FINAL ENVIRONMENTAL IMPACT REPORT

DUDLEY TRIANGLE NEIGHBORHOOD
Roxbury, Massachusetts

DUDLEY STREET NEIGHBORHOOD INITIATIVE
Roxbury, Massachusetts

April 1993

EOEA-7963 EIR Figure 2.0-2

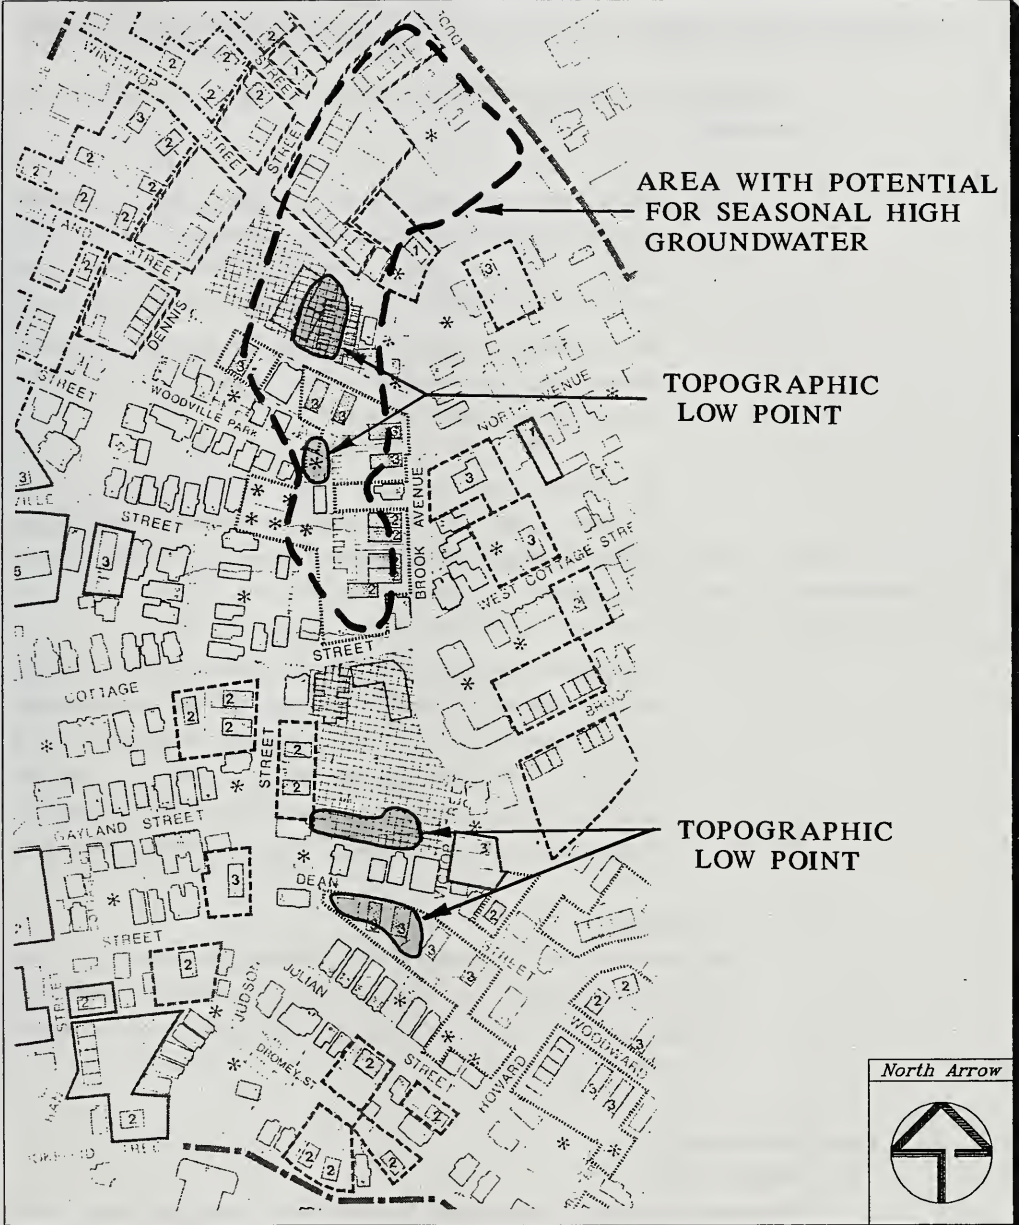
- (1) A map will be provided to show the area of low topography where flooding may occur and the location of proposed buildings. Detailed flooding calculations to determine flood levels will not be required.
- (2) Potential mitigation measures to minimize possible flooding problems to which the project proponent will commit will be described.

Comment 18 *"The DEIR indicates that some localized street flooding occurs in the
area. The proponent is requested to identify where street flooding may
occur under the proposed conditions."*

"The Final EIR should describe in more detail the mitigation measures which will be adopted to avoid the potential flooding problems."

1. Perimeter drains may be installed on the buildings within the area identified on the map (Figure 2.0-2), as having the potential for localized flooding.
2. Basements within the area may either be water-proofed or provided with a sump pump if, by subsurface investigation, it is determined that groundwater may reach within 12 inches of the proposed basement floor elevation.
3. Low areas may be raised with the installation of clean fill to bring the grade up to provide positive drainage toward the street.

The potential exists for areas within the project site to have some minor localized flooding and the potential for seasonal high groundwater. Observations were made in the field to identify these sites. Topographic information was also used to identify the areas with potential seasonal high groundwater (predominantly the area near where the Brook once existed). Figure 2.0-2 shows the various areas for potential flooding.

The proponent will provide mitigation in the areas identified on Figure 2.0-2 as having the potential for localized flooding. In areas of potential high groundwater, mitigation will be provided as needed in the form of either basement waterproofing, construction without basements, foundation drainage systems or utilizing sump pumps. The need for such mitigation will be determined by on-site subsurface investigation. Appropriate mitigation measures will be determined by the Architect responsible for preparing the project specifications.

Figure 6.0-1

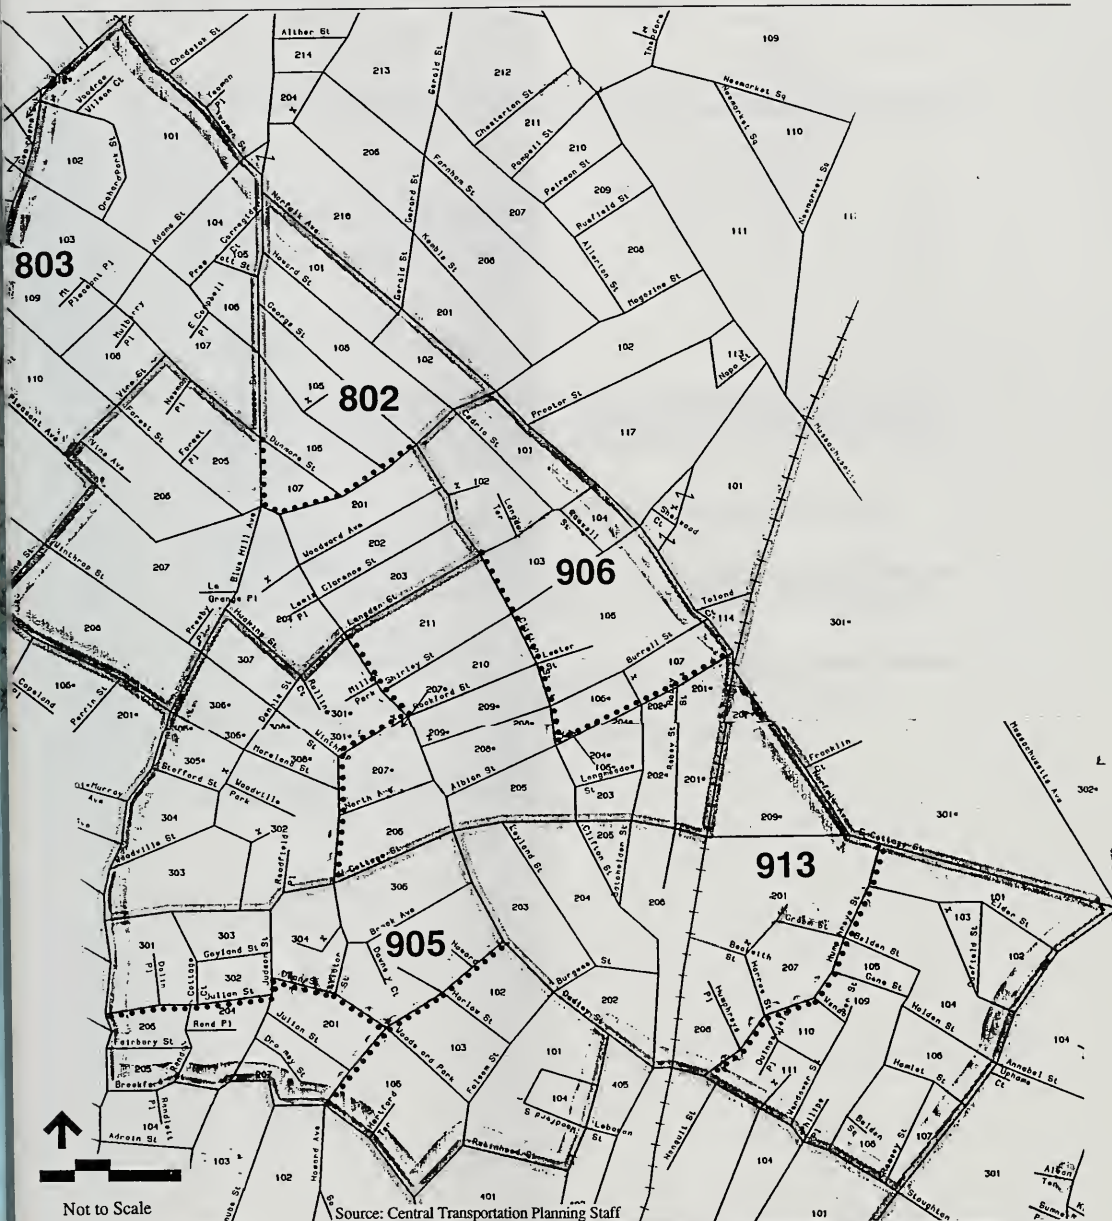
"On Figure 6.0-1, the Dudley Station National Register District also should be included on the map. Furthermore, the Historic Background discussion (section 6.3.3) does not include the Plantation Period (1620-1675) although this period is referenced on page 6-12 with regard to the potential for artifacts. These corrections should be made to the Final EIR."

Figure 6.0-1 was modified to include the Dudley Station National Register District, northwest of the project site and is included in Appendix E of this report.
